PUBLIC UTILITIES COMMISSION OF THE STATE OF CALIFORNIA

RESOLUTION SU-6
November 21, 1990

RESOLUTION SU-6, ORDER AUTHORIZING RULE CHANGES TO GENERAL ORDER NO.95 (G.O.95) , RULES FOR OVERHEAD ELECTRIC LINE CONSTRUCTION AND GENERAL ORDER NO.128 (G.O.128) , RULES FOR CONSTRUCTION OF UNDERGROUND ELECTRIC SUPPLY AND COMMUNICATION SYSTEMS

Figure 54-2
Partial Underground

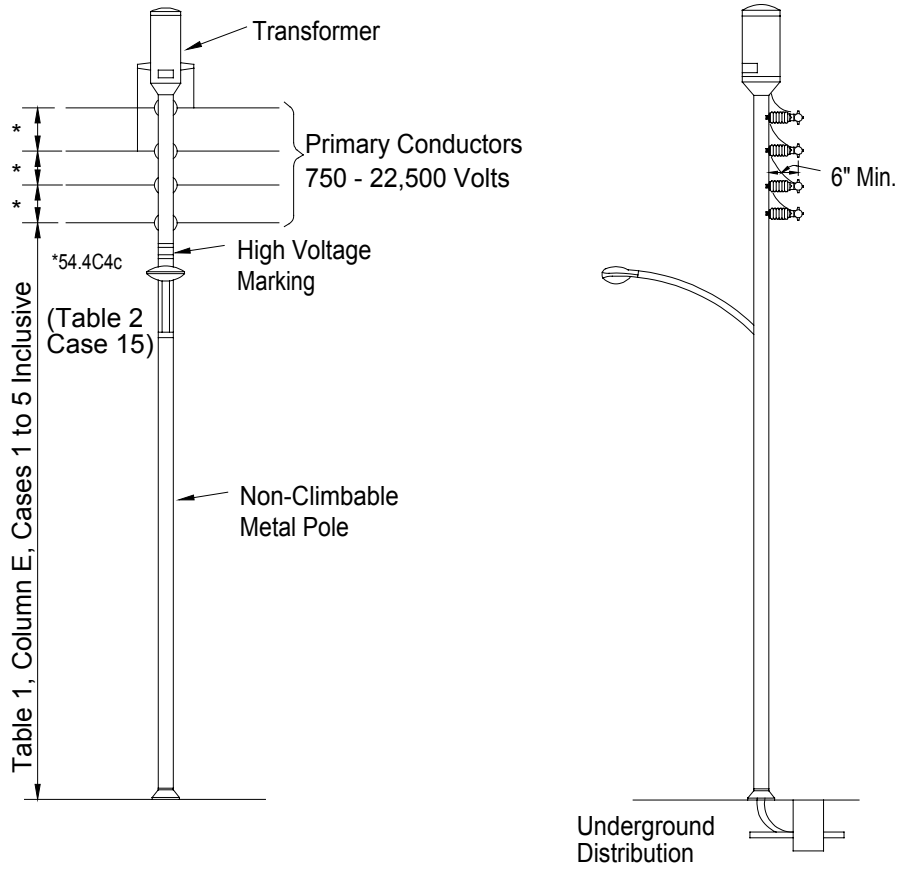
This rule was established in 1964 and placed certain restrictions where conductors of more than 750 volts are supported (dead ended) in vertical configuration on non-climbable pole in partial underground distribution at line terminations, angles, or corners.

The requirement of not allowing more than three conductors of a single circuit of 750-22,500 volts to be supported (dead ended) direction the pole in vertical configuration without the use of crossarms should be changed to allow four conductors. This change will allow safe, cost effective conversion of three-phase three wire 12 kV to three-phase four wire 21 kV distribution circuits. Currently a fourth conductor can be attached to a pole in tangent construction, the restriction applies to dead end configuration only.

There are currently two alternatives to dead ending a fourth wire on a pole with three wires already dead ended at that location. One is the installation of additional poles to permit the attachment of the fourth wire to the dead end pole in a tangent configuration and dead ending it a span away. The other is to underground the neutral conductor the entire length of the partial underground portion of the circuit. Both of these alternatives are costly and afford more exposure to workman and the public.

Not more than ~~three~~ four conductors of a single circuit of 750-22,500 volts shall be supported directly on the pole in vertical configuration without the use of crossarms, Branch circuits may be taken from such construction without the use of crossarms provided that conductors are supported on not more than three sides of the pole, there being four sides (see App. G, Fig. 88);

Clearance Over Swimming Pools
Figure 54-8

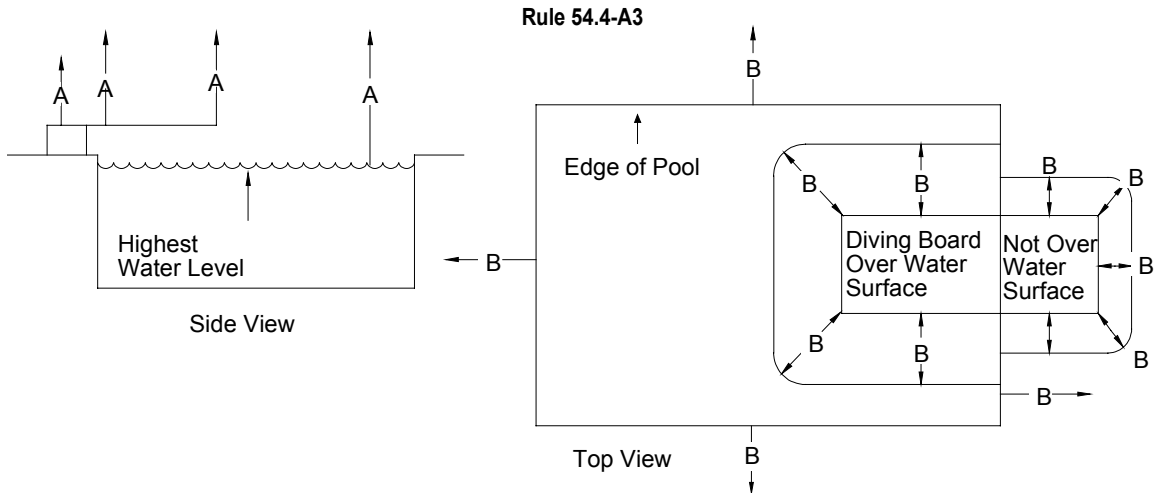
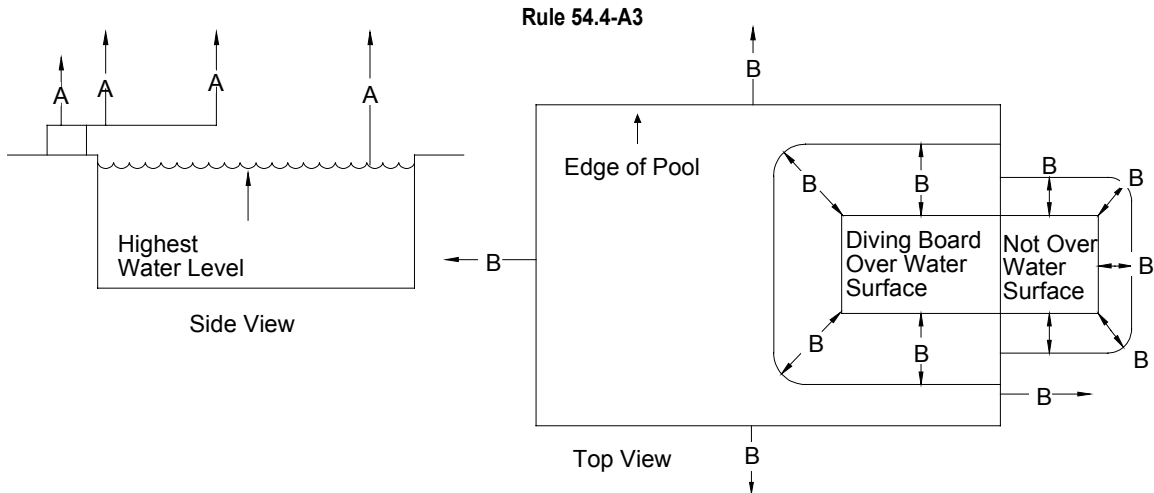
These proposed rule changes reformat the text to simplify obtaining (and clarification of) the vertical and radial clearances above swimming pools. A sketch and table (Fig. 54-8) have been added for clarification of the text.

- 3) Shall not be installed less than 18 feet vertically above the horizontal plane through a diving board or platform, such plane being the area within 8 feet radially of the diving board or platform that is over the water surface of the pool.

- 4) Shall not be installed less than 12 feet vertically above the horizontal plane through a diving board or platform, such plane being the area within 6 feet radially of the diving board or platform that is not over the water surface of the pool.

- (d) Grounded Portions of Guys:
- 1) Shall have vertical clearances above the highest water level of the pool surface of not less than 16 feet.
 - 2) Shall not be installed less than 16 feet vertically above the horizontal plane through a diving board or platform, such plane being the area within 8 feet radially of the diving board or platform that is over the water surface of the pool.

- 3) Shall not be installed less than 8 feet vertically above the horizontal plane through a diving board or platform, such plane being the area within 3 feet radially of the diving board or platform that is not over the water surface of the pool.

Figure 84-2

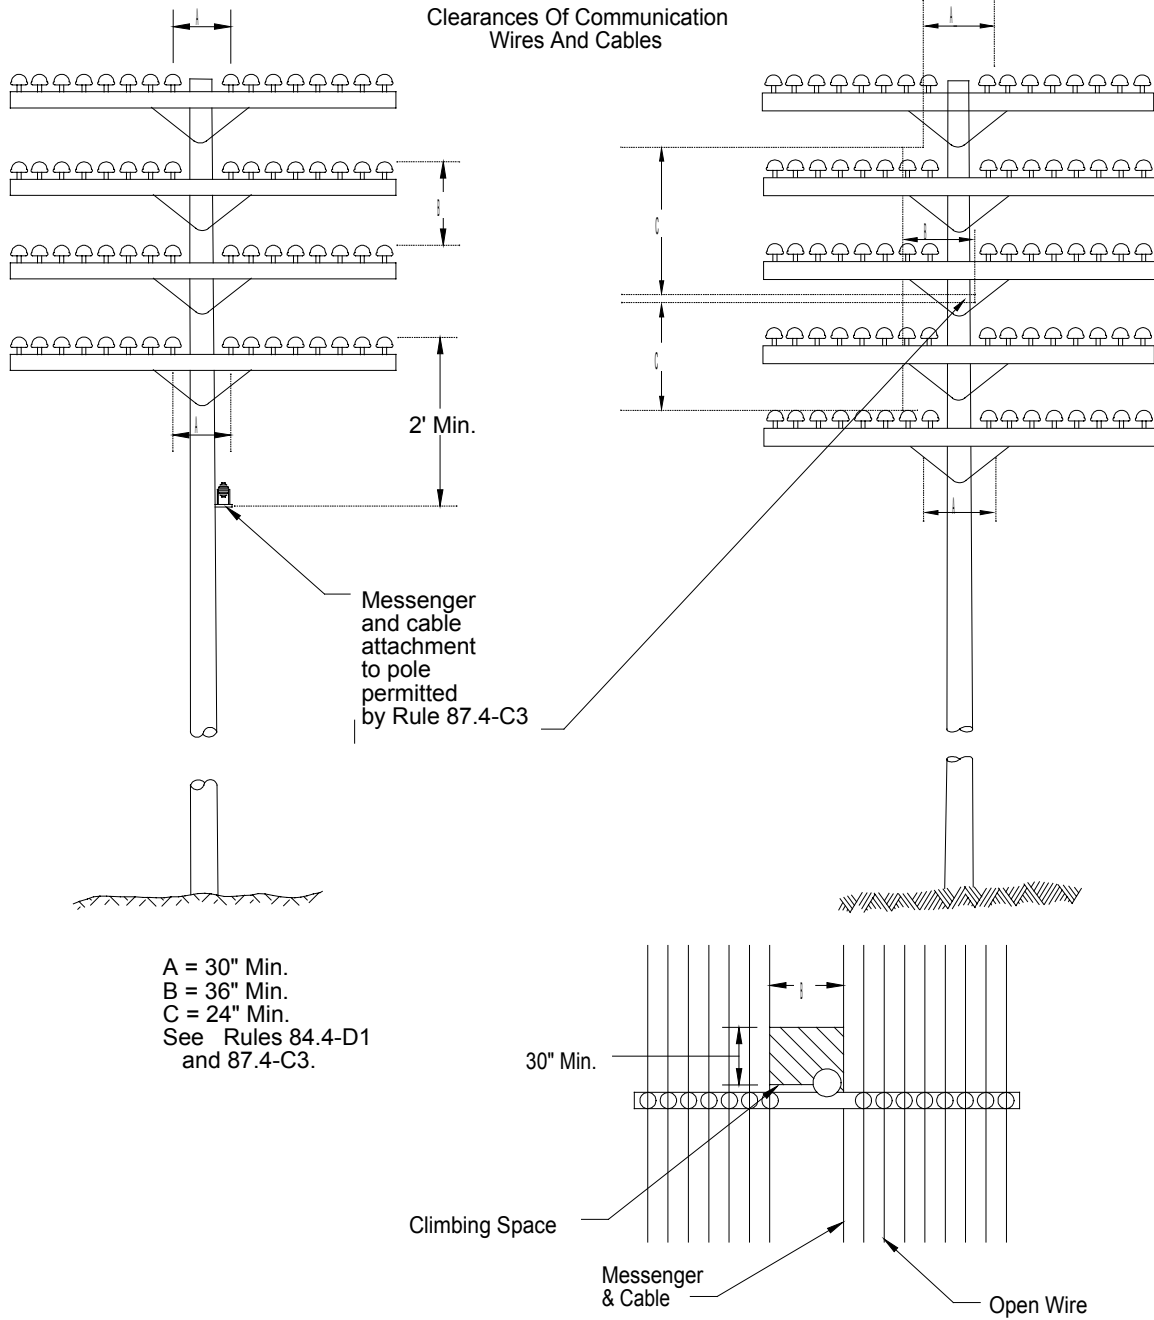
~~where placed between crossarms or less than 2 feet below the level of the lowest communication conductor supported on crossarms provided, for climbing space purposes, such~~ These cables or messengers are to be placed on one side of the pole only and. Any conductor (supported by on a crossarm and on the opposite side of the pole) which that is within 36 inches vertical may from the level of the cable or messenger shall be at least is not less than 24 inches (if an exchange conductor) or 18 inch (if a toll conductor) horizontally from the vertical plane of such cable or messenger. (See App. G, 84: Fig 84.2)

- 1) When placed between crossarms, or
- 2) When placed less than 2 feet below the level of the lowest communication conductor supported on crossarms.

These cables or messengers are to be placed on one side of the pole only and. Any conductor on a crossarm on the opposite side of the pole that is within 36 inches vertical may of the cable or messenger shall be at least 18 inch horizontally from the vertical plane of such cable or messenger. (Fig 84.2)
